PLAN REVIEW SHEET

Petition:

2016-131

Halvorsen Development Corporation

Bus stop pad detail

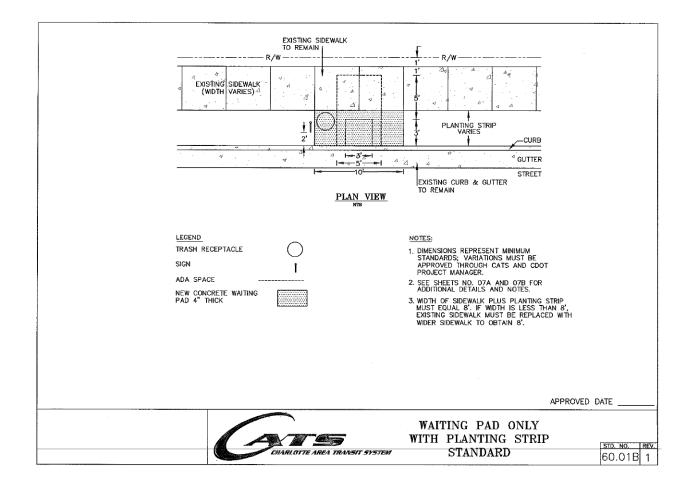
This site is located on a future bus route that is planned to start service next year, following the opening of the LYNX Blue Line Extension. The Petitioner is requested to provide and construct a new waiting pad for a new bus stop on Prosperity Church Road.

Below is an image of the standard detail (60.01B) for the requested bus stop pad. Permanent easement is requested, where dimensions exceed existing or proposed right-of-way limits.
